Falcon Highlands South Filing No. 1

Final Drainage Report

SF2418

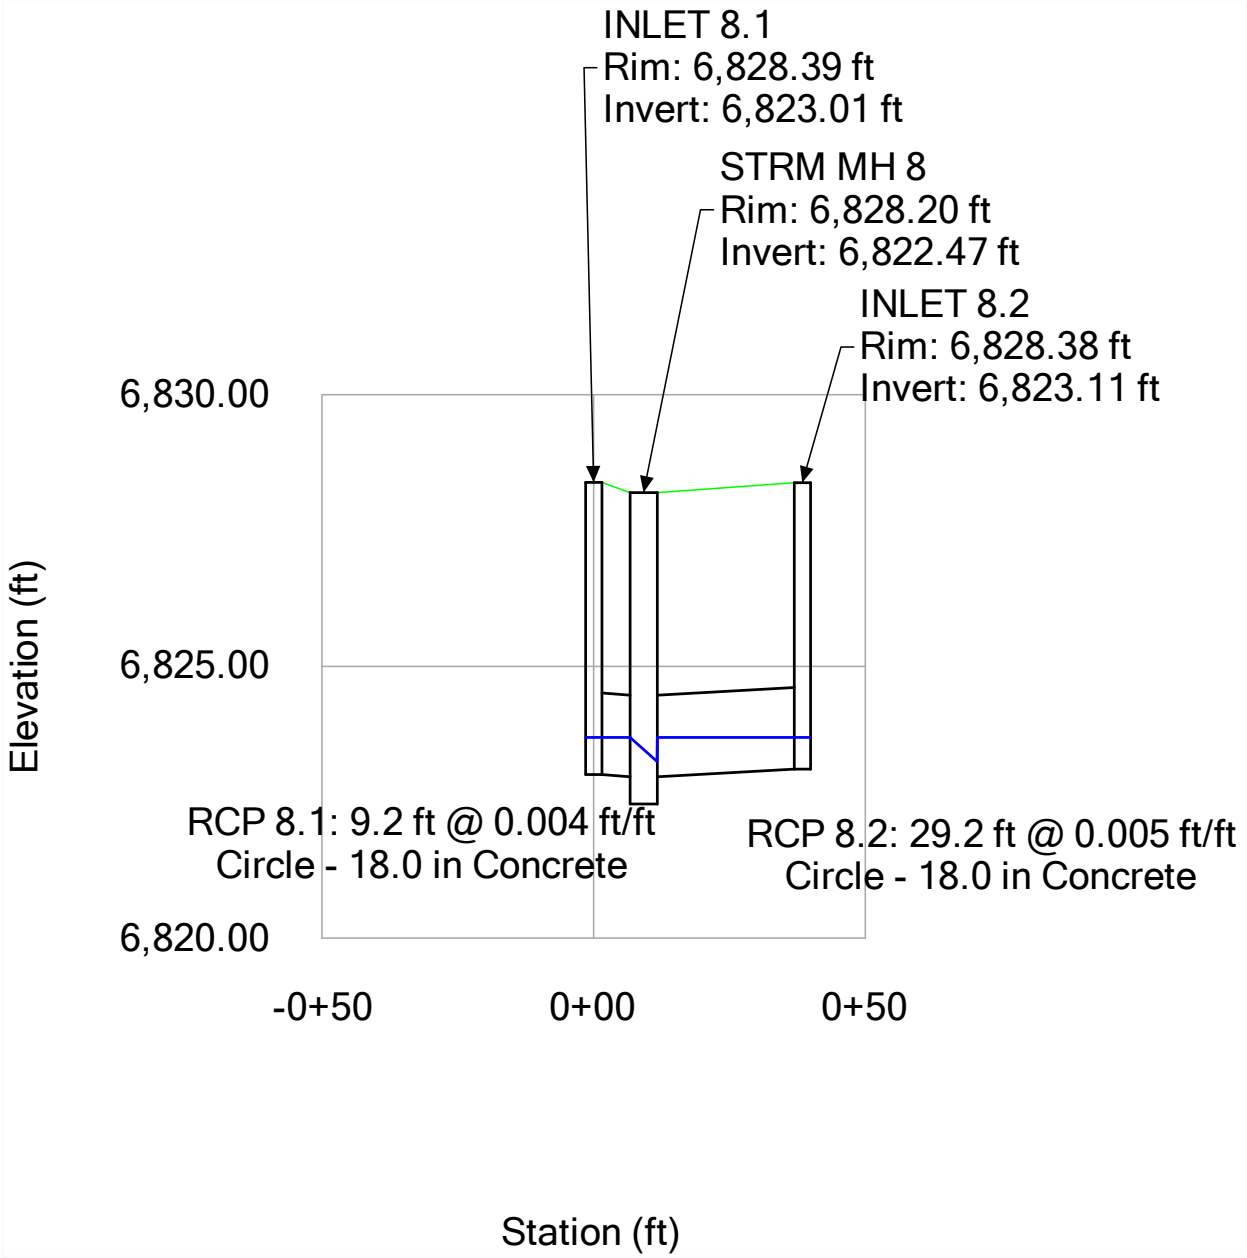
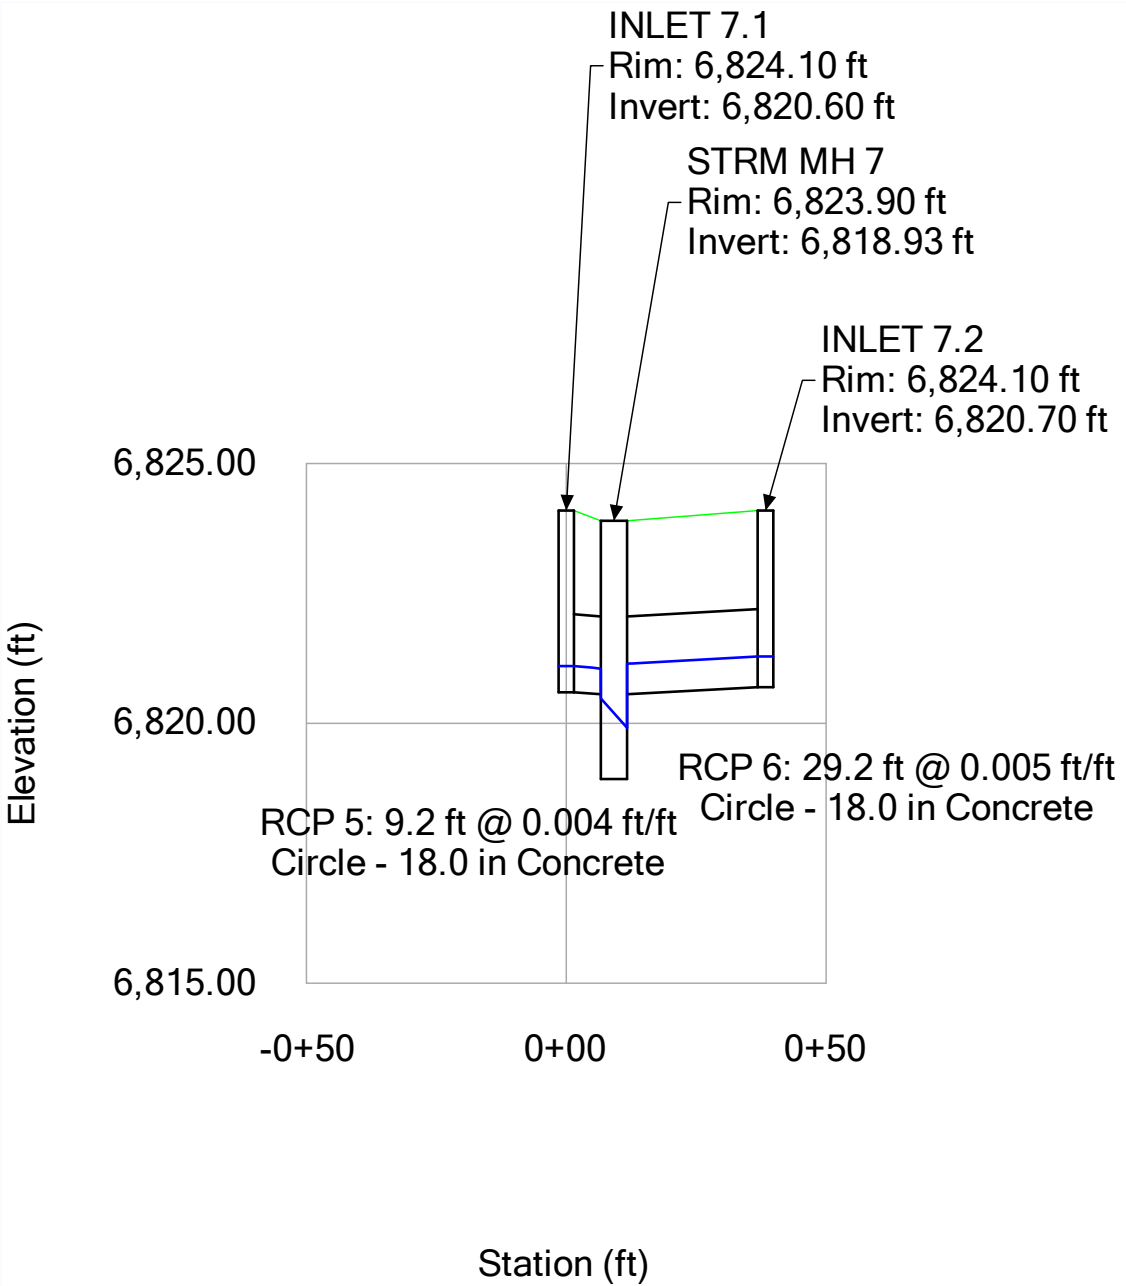
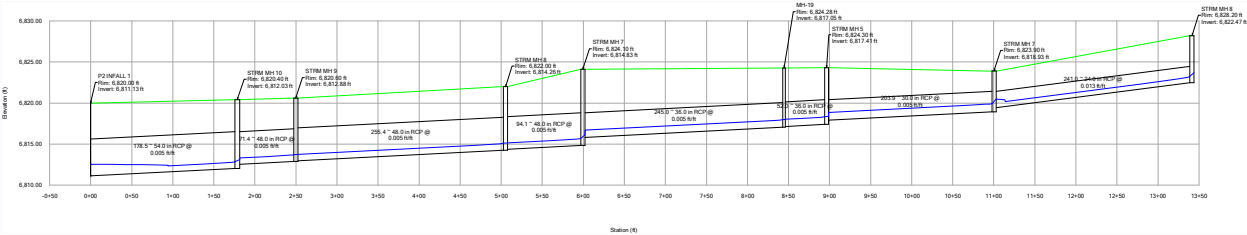
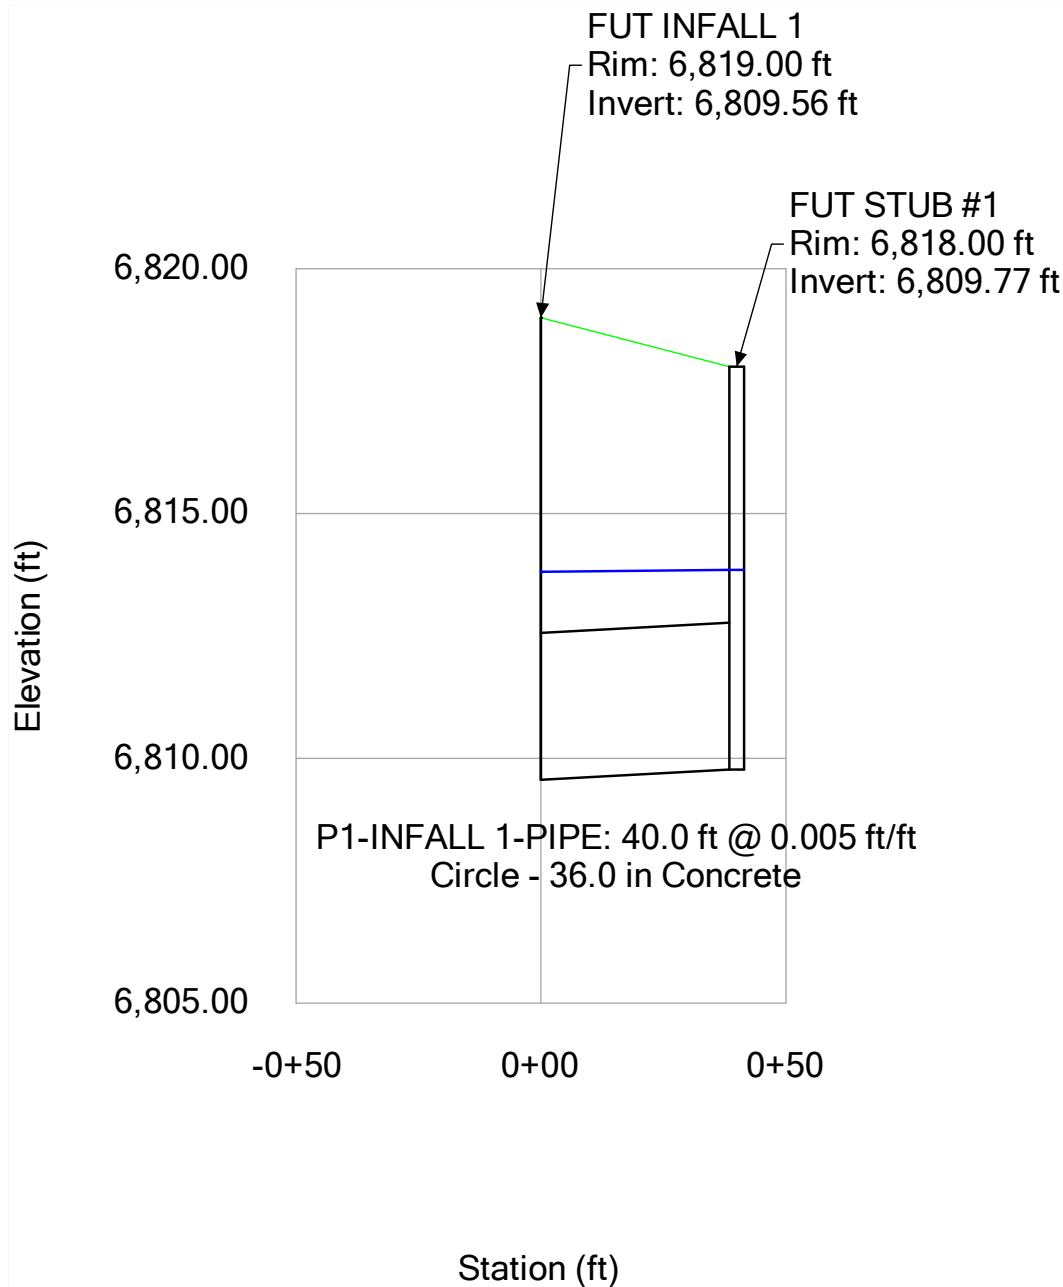
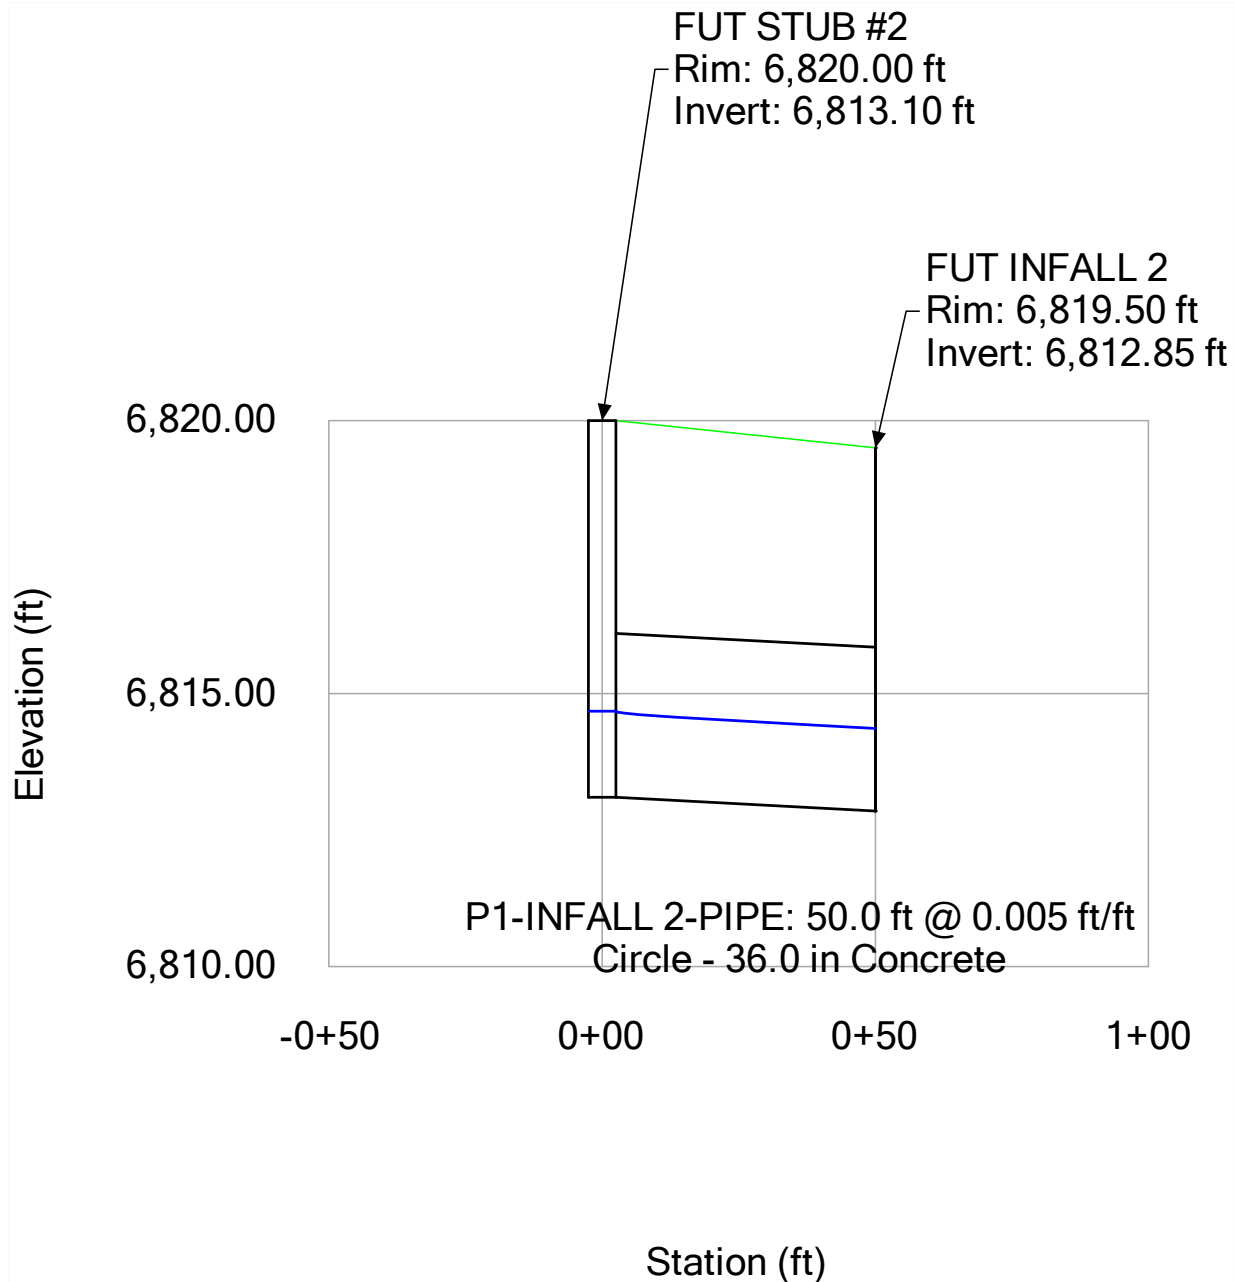
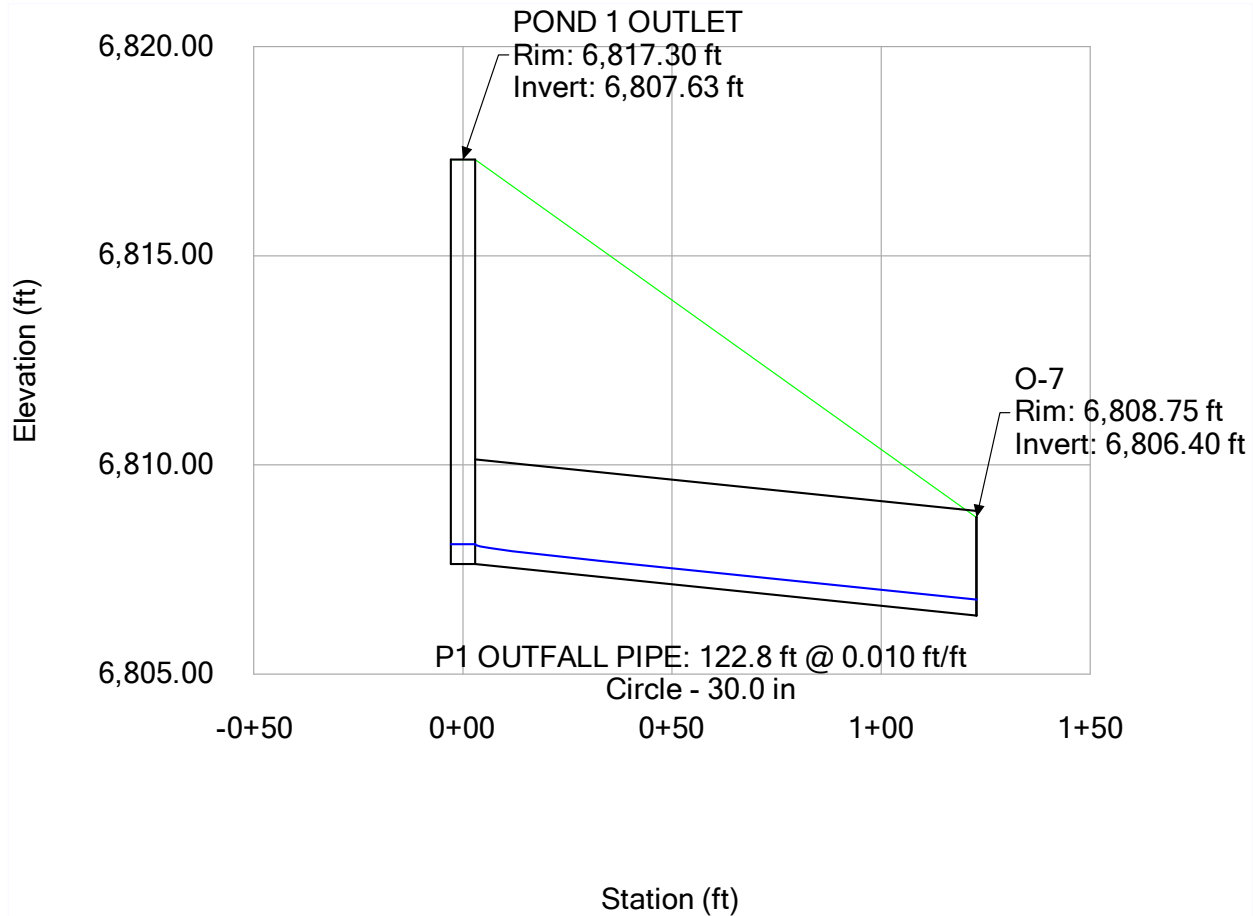
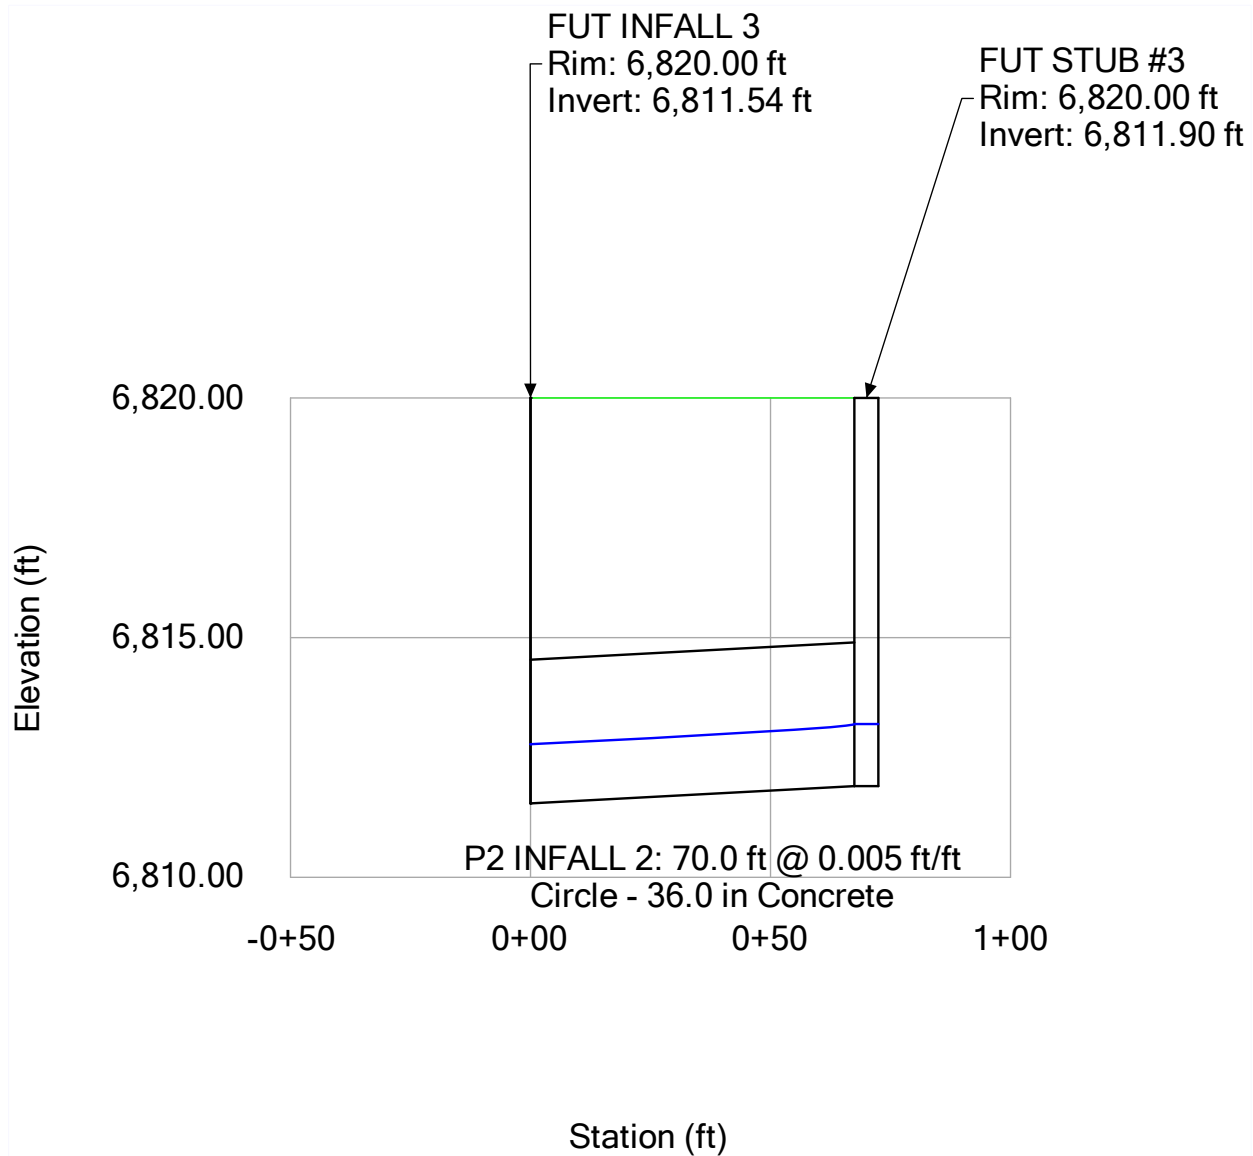
Unresolved Review 6 & 7 comment:
Inconsistencies between stormcad design, conduit table, and CDs.
See version 7 comments on CDs as it appears no updates were made to pipe lengths with this submittal. Please check entire system for accuracy.
It would be helpful if naming convention was consistent between stormcad and CDs.
